Instituting a Proceeding to Investigate
Integrated Grid Planning.

DOCKET NO. 2018-0165

HAWAIIAN ELECTRIC COMPANIES'
REPLY TO PARTY COMMENTS AND COMMISSION QUESTIONS

Figure 1: Forecast 1 - LCOE for select resources based on the forecasted resource cost filed on August 2021.

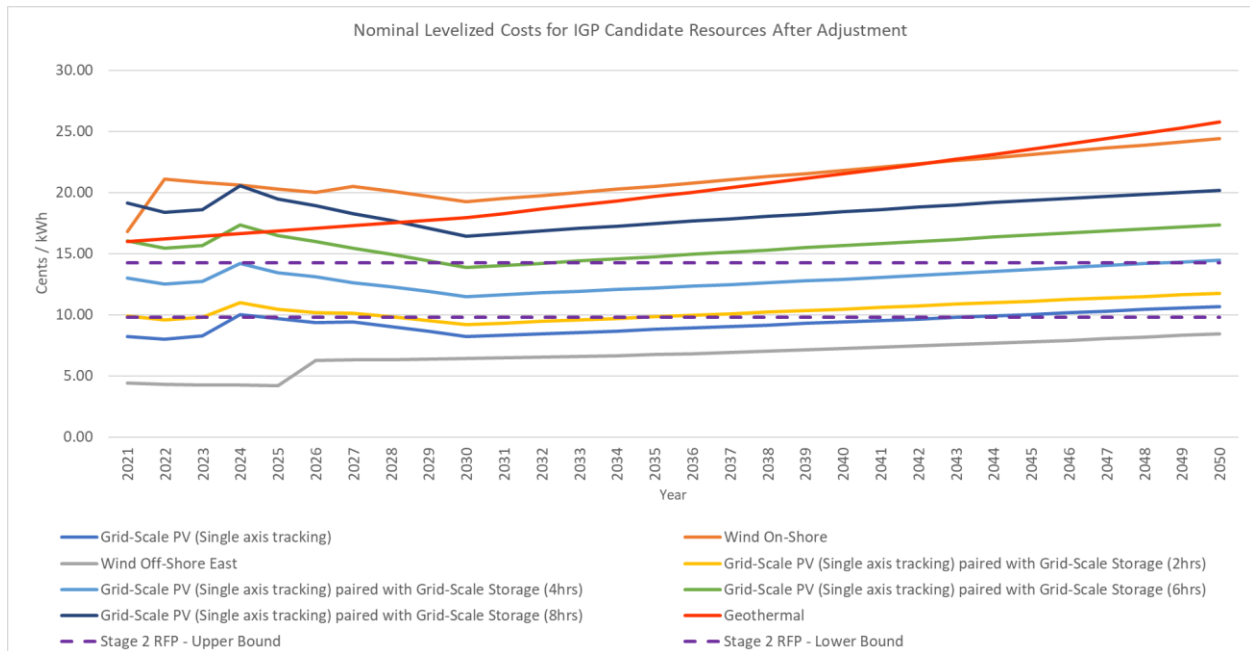
However, after updating these spreadsheets to use NREL ATB 2021 data, we have not been able to exactly reproduce the RESOLVE inputs that Hawaiian Electric published in August 2021, particularly for geothermal power. We were also unable to reproduce the multipliers that Hawaiian Electric reported using to benchmark NREL ATB-based costs to reflect the cost of recent renewable energy projects in Hawaii. Before modeling begins, we recommend that Hawaiian Electric provide copies of all the spreadsheets used for this calculation, including those used for benchmarking, so the process can be reviewed and verified to be correct.²³ (footnote omitted)

The Companies provided the results of the resource cost forecast proposals as follows:

Shown above in Figure 1 is the levelized cost of energy (“LCOE”) for select resources based on Forecast 1, which is the forecast that was provided in the August 3, 2021 filing. Based on feedback from Uluopono, the first correction made was for the application of the State ITC to grid-scale PV. The August 3rd filing assumed the State ITC was still available to future grid-scale PV. Uluopono referenced the latest version of the Renewable Energy Technologies Income Tax Credit (RETITC) – HRS § 235-12.5²⁴ which states that the State ITC for solar energy systems cannot be applied to systems larger than 5 MW if it does not have an approved or pending PPA by the PUC by December 31, 2019. As a result, Forecast 2 was developed which takes Forecast 1 and removes the State ITC for future grid-scale PV. Shown below in Figure 2 is the LCOE for select resources based on Forecast 2.

Figure 3: Forecast 3 - LCOE for select resources based on Forecast 2 with the adjustment of the Federal ITC for Utility PV, Onshore Wind, and Offshore Wind.

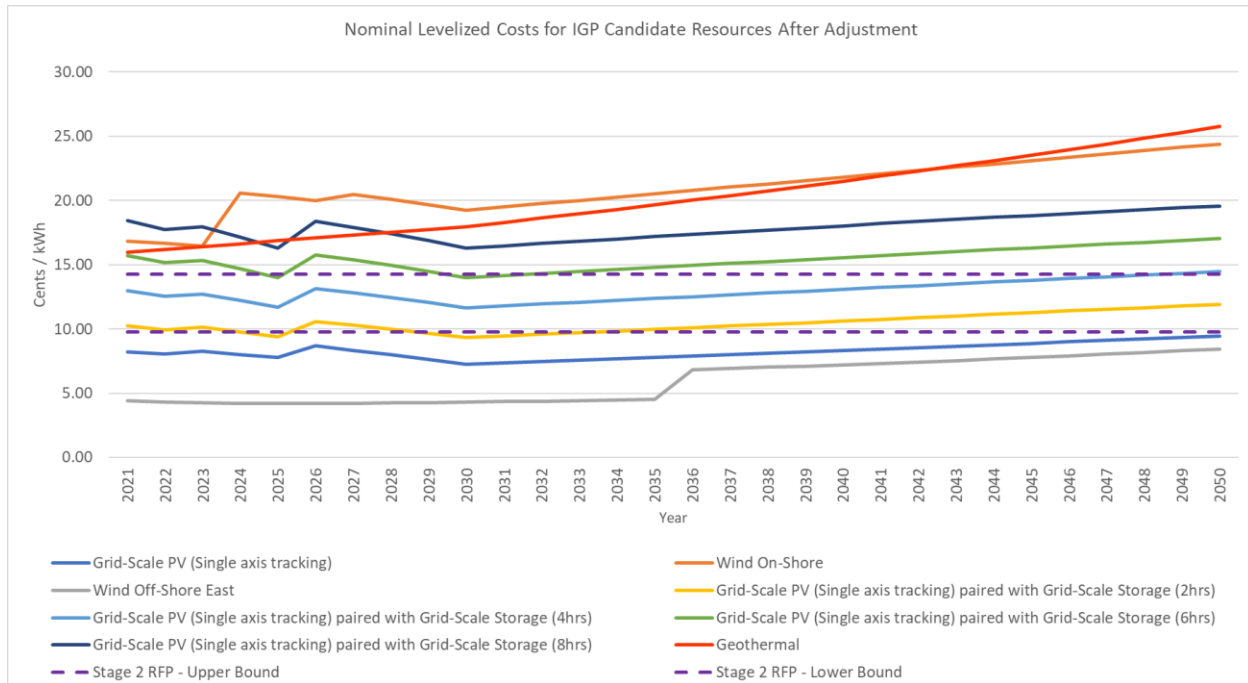
Based on feedback from Progression Energy and Ulupono, the next correction made was to the Federal ITC. Ulupono noted a discrepancy between the Federal ITC being used for grid-scale PV in the August forecast and what is shown on the Database of State Incentives for Renewables & Efficiency (“DSIRE”)²⁵. After review, the Federal ITC was adjusted to match what is shown on DSIRE.

The August IGP Update shows 10% federal tax credits for solar projects started in 2024 or 2025, but the DSIREUSA database⁴ shows 22% credits in these years. We recommend that Hawaiian Electric verify that they are using the correct schedule of federal tax credits before running the model.³¹ (footnote omitted)

NREL's draft O'ahu Offshore Wind Study was 10 years²⁶. Forecast 3 was developed which takes Forecast 2 and adjust the Federal ITC for grid-scale PV, onshore wind, and offshore wind. Shown below in Figure 3 is the LCOE for select resources based on Forecast 3.

See response to Ulupono-1. The Federal ITC was updated for PV, consistent with the rate shown on the DSIREUSA database. The State ITC was removed for PV to reflect current law.

Figure 4: Forecast 4 - LCOE for select resources based on Forecast 3 and incorporating the Utility-Scale PV-Plus-Battery cost provided in the 2021 ATB forecast to derive the cost for the paired PV and paired BESS.

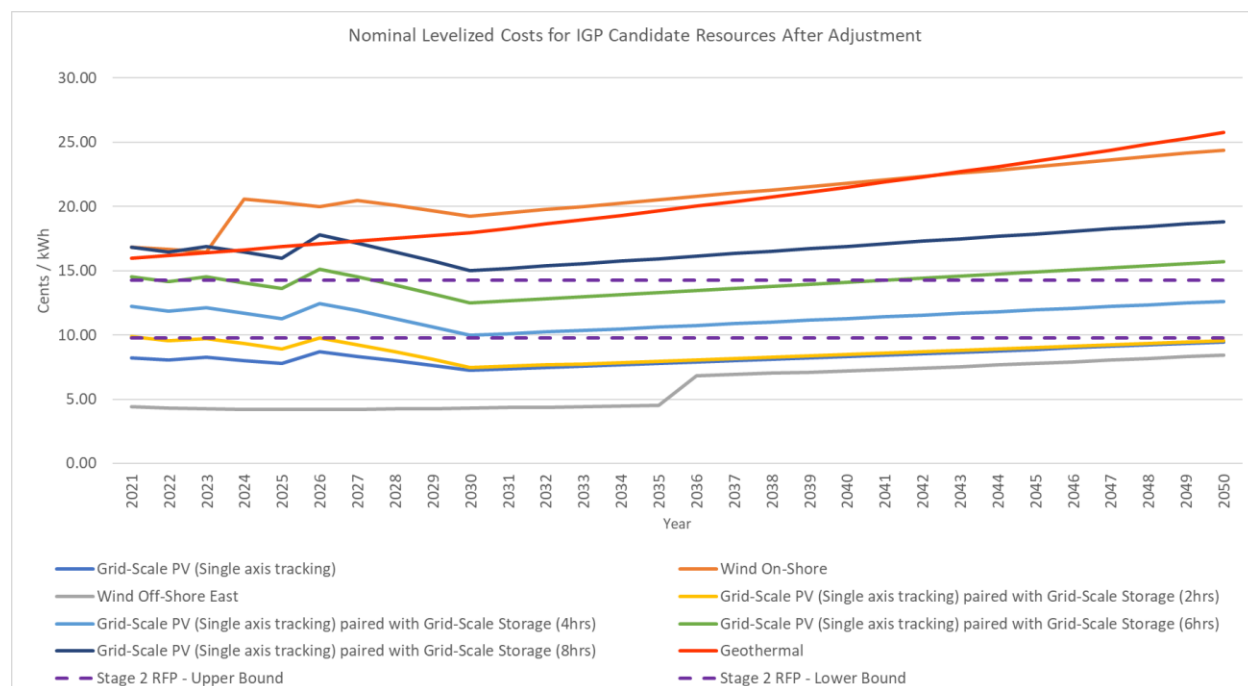
Ulupono also recommended that for paired PV with BESS, Hawaiian Electric use the cost for Utility-Scale PV-Plus-Battery that was provided in the 2021 ATB forecast rather than the separate costs for standalone PV and standalone BESS. After consideration, Hawaiian Electric incorporated this recommendation. The forecast provided in the 2021 ATB for Utility-Scale PV-Plus-Battery assumed that the paired BESS had a fixed 4-hr duration. To estimate the cost for paired BESS that had 2-, 6-, and 8-hr duration, the cost was scaled proportionately. Forecast 4 started with Forecast 3 and used the Utility-Scale PV-Plus-Battery cost provided in the 2021

ATB forecast to derive the cost for the paired PV and paired BESS. Shown below in Figure 4 is the resulting LCOE for select resources based on Forecast 4.

See response to Ulupono-1. The resource costs for paired projects was revised to use the Utility-Scale PV-Plus-Battery worksheet from the NREL ATB published in 2021.

Figure 5: Forecast 5 - LCOE for select resources based on Forecast 4 and using the NPV benchmark methodology to benchmark the cost to recent 20- or 25-year PPAs.

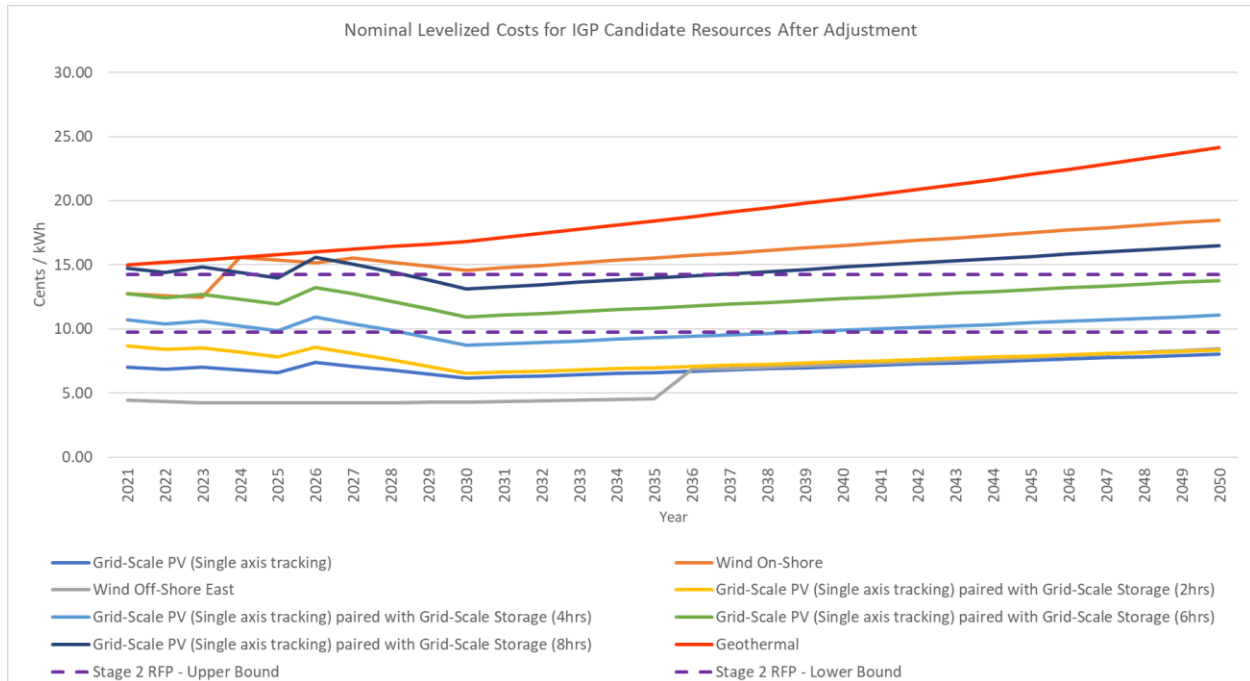
Ulupono also recommended benchmarking to projects that have either 20- or 25-year PPAs. To do this, Ulupono suggested converting the annual lump sum payments to an NPV, and use that as a proxy capital cost. Hawaiian Electric incorporated this recommendation and used this NPV method to benchmark the resource cost to recent 20- or 25-year PPAs. Forecast 5 starts with Forecast 4 and incorporates the NPV benchmark methodology to benchmark the cost to recent 20- or 25-year PPAs. Shown below in Figure 5 is the resulting LCOE for select resources based on Forecast 5.

We recommend that Hawaiian Electric use benchmarks based on projects that have either a 20 or 25 year power purchase agreement ("PPA"), rather than just using the ones with 25 year PPAs, as reported in July 2021. One way to do this would be to convert the PPA cost streams for each project into a net present value ("NPV") in the year of construction, which can then be used as a proxy capital cost. This method will also make it possible to benchmark battery energy storage projects that have variable payment streams. This change is likely to broaden the pool of projects that are included in the benchmark, but we do not expect it to significantly alter the benchmark cost.²⁹

See response to Ulupono-1. The benchmarking was redone on a net present value basis to include both 20 and 25 year PPAs to further increase the data points used in the benchmarking.

Figure 6: Forecast 6 - LCOE for select resources based on Forecast 5 and using the actual size of NPM to benchmark the Onshore Wind cost and use the EIA locational adjustment factor for Offshore Wind.

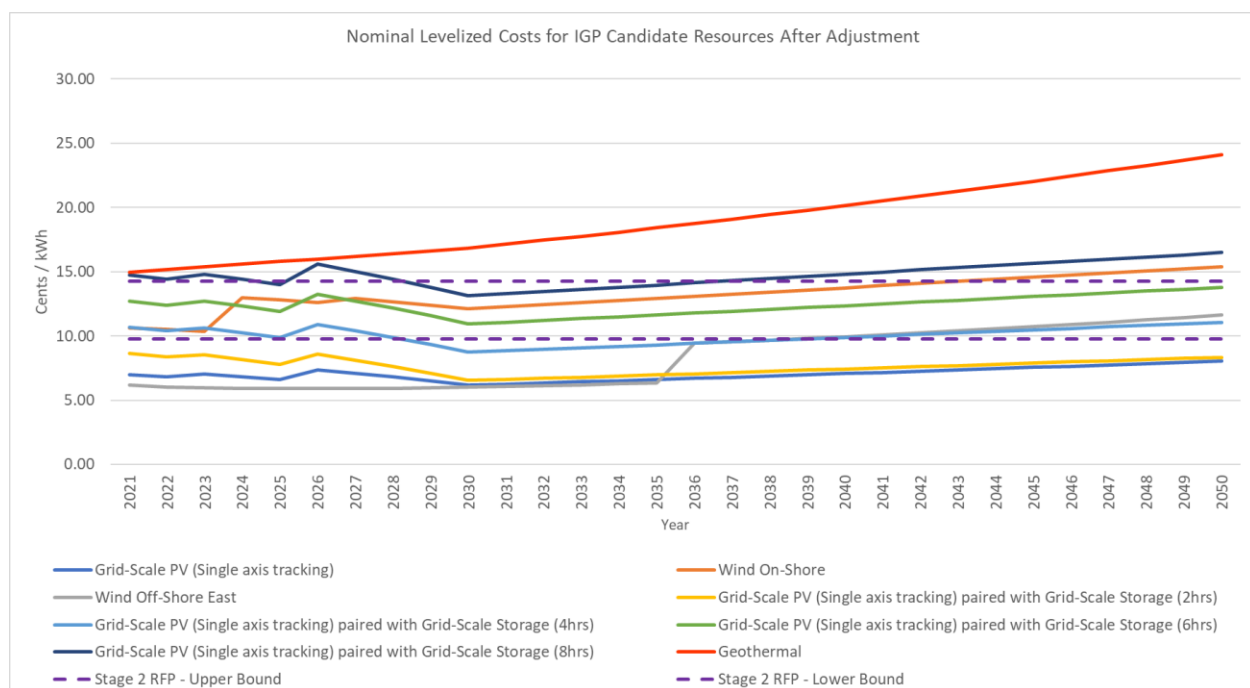
Ulupono had concerns about the cost spread between the onshore wind cost and the offshore wind cost. Two adjustments were made to the forecast to help reduce the spread. The first change was recommended by Ulupono. Ulupono recommended that Hawaiian Electric use the actual size of existing projects when calculating the cost for benchmarking, rather than a standard 1 MW size. Since the State ITC has a cap, the size being used impacts whether the limit on the State ITC would be reached. If the limit is reached, this would impact the tax savings and resulting cost, and consequently, the scaling factor used to benchmark the resource cost. Since there is no longer a State ITC for grid-scale PV and geothermal does not have a cap on its ITC, this recommendation would only impact the benchmarking for onshore wind, which is scaled to Na Pua Makani. After consideration, this recommendation was incorporated.

Hawaiian Electric also reached out to NREL to discuss how they made the offshore wind cost specific to Hawai‘i in their draft O‘ahu study. NREL noted adjustments made to the capital and related transportation costs but labor adjustments were not identified. Because the EIA location adjustment factor accounts for labor wage and productivity differences, the Company decided to include the EIA location adjustment factor that was used for onshore wind. Forecast 6 was developed which takes Forecast 5 and uses the actual size of Na Pua Makani to calculate the scaling factor to adjust the cost for onshore wind, as well as apply the EIA location adjustment factor to offshore wind. Shown below in Figure 6 is the LCOE for select resources based on Forecast 6.

See response to Ulupono-1. The EIA location adjustment factor for wind was incorporated into the offshore wind resource cost. Although the O‘ahu offshore wind study did consider Hawai‘i specific factors such as identification of ports and grid connection infrastructure, customized export cable sizes, hurricane resilience, and transportation cost premium, labor and productivity differences were not considered. Labor and productivity differences are accounted for in the EIA location adjustment factor.

Figure 7: Forecast 6HE - LCOE for select resources based on Forecast 6 but benchmarking for paired PV and paired BESS based on 20- and 25-year PPAs on O‘ahu only.

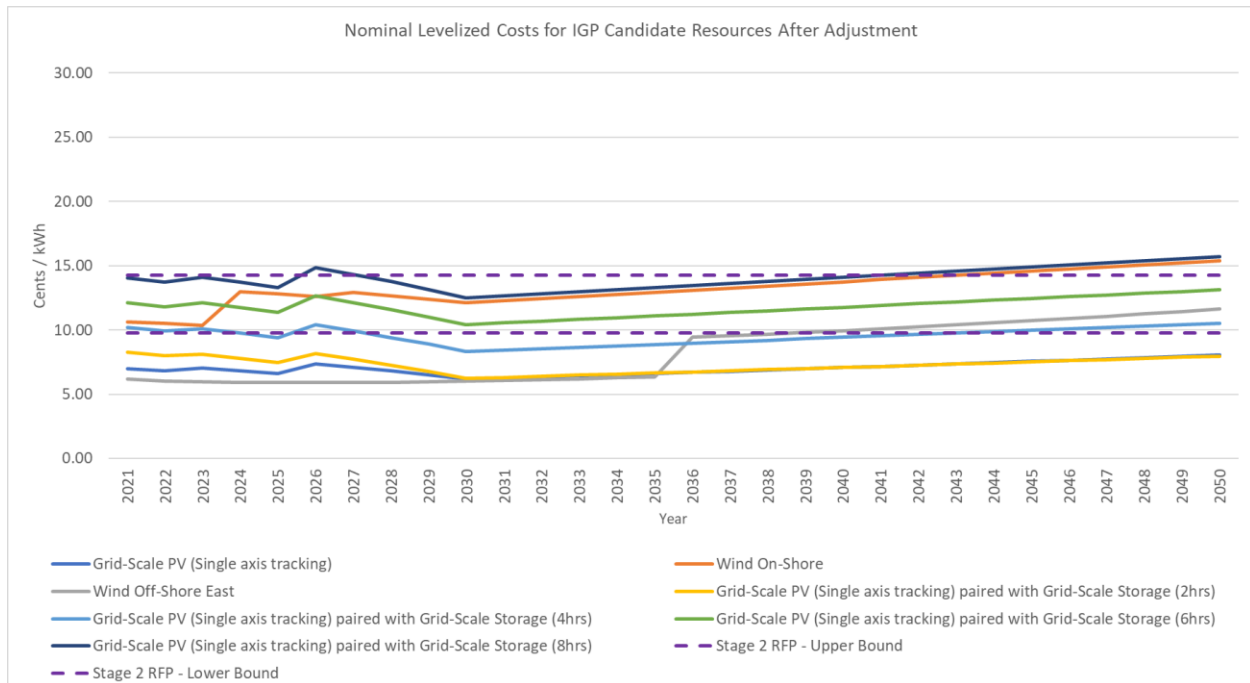
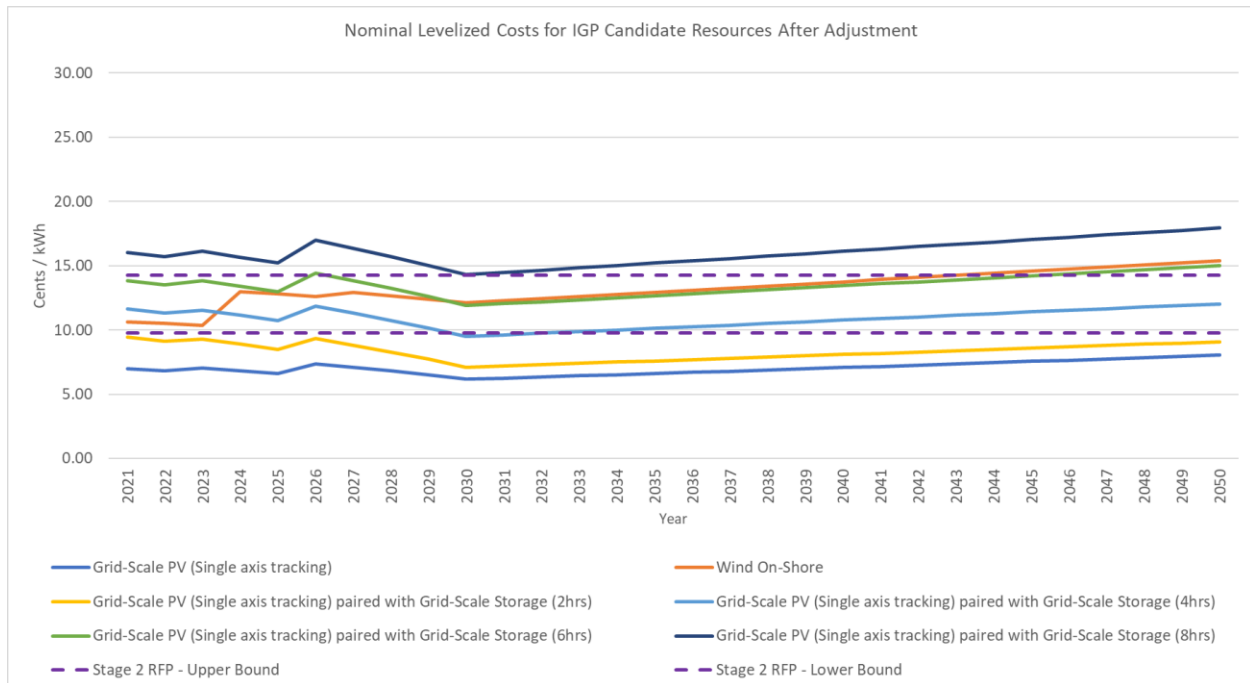
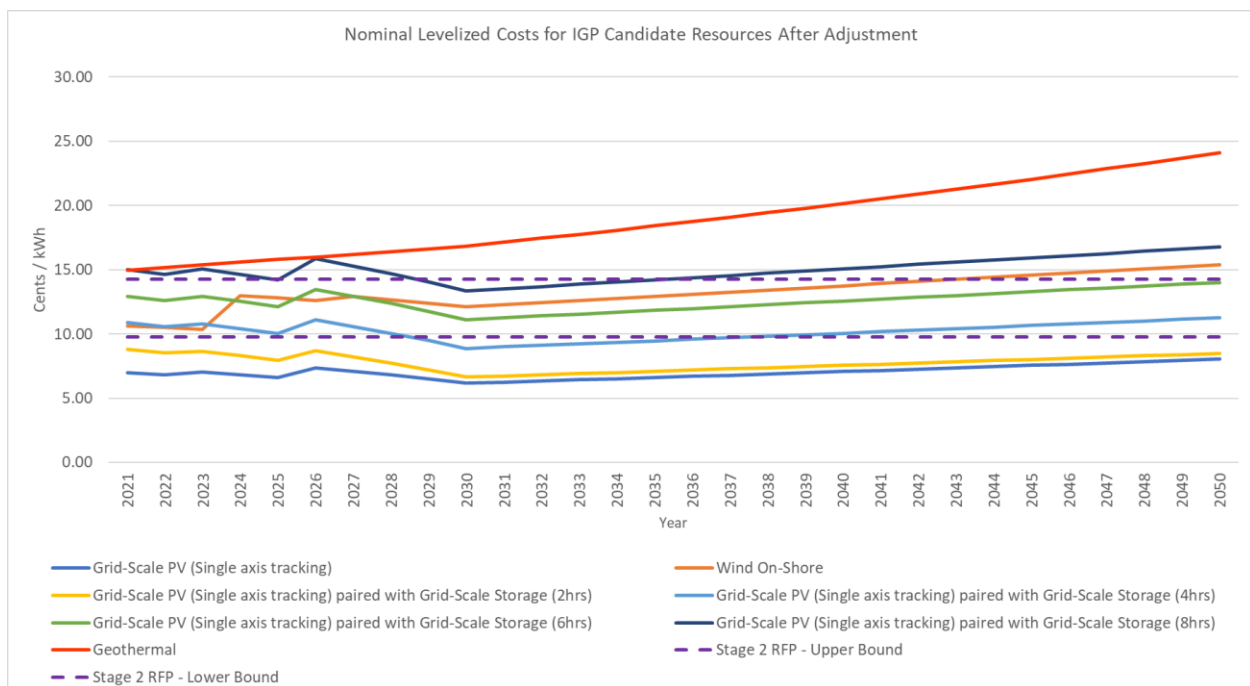
Ulupono also recommended Hawaiian Electric use existing projects on each island to benchmark the cost of projects on that island, rather than using projects across all islands. This may be possible to do for paired PV and paired BESS due to the number of recent projects from the Stage 1 and Stage 2 RFPs on O‘ahu, Maui, and Hawai‘i Island. As noted in Ulupono-3, however, it is not clear that projects cost more on Maui and Hawai‘i Island relative to O‘ahu, which appears to be Ulupono’s main driver to separately benchmark by island. Nevertheless, Hawaiian Electric still tested this recommendation to determine its impact. For resources other than paired PV and paired BESS, however, there are not enough recent projects to benchmark the islands separately, and using older projects may not provide an accurate target cost to benchmark against.

Forecast 6HE starts with Forecast 6 and incorporates the NPV benchmark methodology to benchmark the cost of paired PV and paired BESS to recent 20- or 25-year PPAs on O‘ahu. Similarly, Forecast 6ME and Forecast 6HEL would use PPAs on Maui and Hawai‘i Island, respectively. Shown below in *Figure 7*, *Figure 8*, and *Figure 9* **Error! Reference source not found.** are the resulting LCOE for select resources based on Forecast 6HE, Forecast 6ME, and Forecast 6HEL, respectively.

Based on *Figure 7* through *Figure 9*, it does not appear that benchmarking paired PV and paired BESS to recent projects on the individual islands had a material impact on the cost.

Figure 10: Forecast 7 - LCOE for select resources based on Forecast 6 and removing the benchmark for all resources.

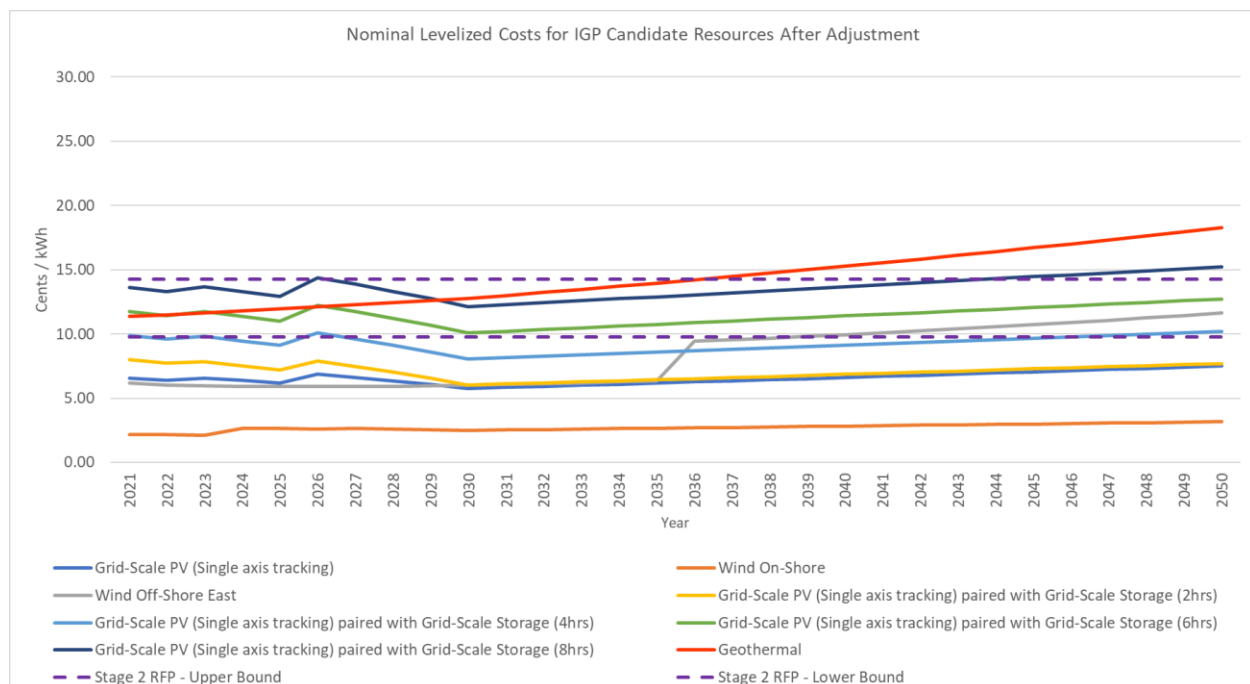
Finally, Ulupono also recommended that the benchmark for onshore wind be removed. Hawaiian Electric tested this recommendation as well. To ensure that all resources were treated similarly, however, the benchmark was removed from all resources. Forecast 7 was developed which takes Forecast 6 and removes the benchmarking. Shown below in *Figure 10* is the LCOE for select resources based on Forecast 7.

Hawaiian Electric presented the above results to representatives from Ulupono on September 17, 2021. After some discussion, both parties agreed that the best path forward at this time is to use Forecast 7 because it uses public data provided by NREL and EIA and can be transparently traced from the source data to the forecast. The consensus was to not use a

The Companies agree that one project may not be enough evidence to benchmark all future projects for a particular resource type. If benchmarking is removed for one technology, all technologies should be treated similarly and all resource costs be forecasted without benchmarking. As discussed in response to Ulupono-1, the Companies and Ulupono have reached agreement to remove all benchmarking.
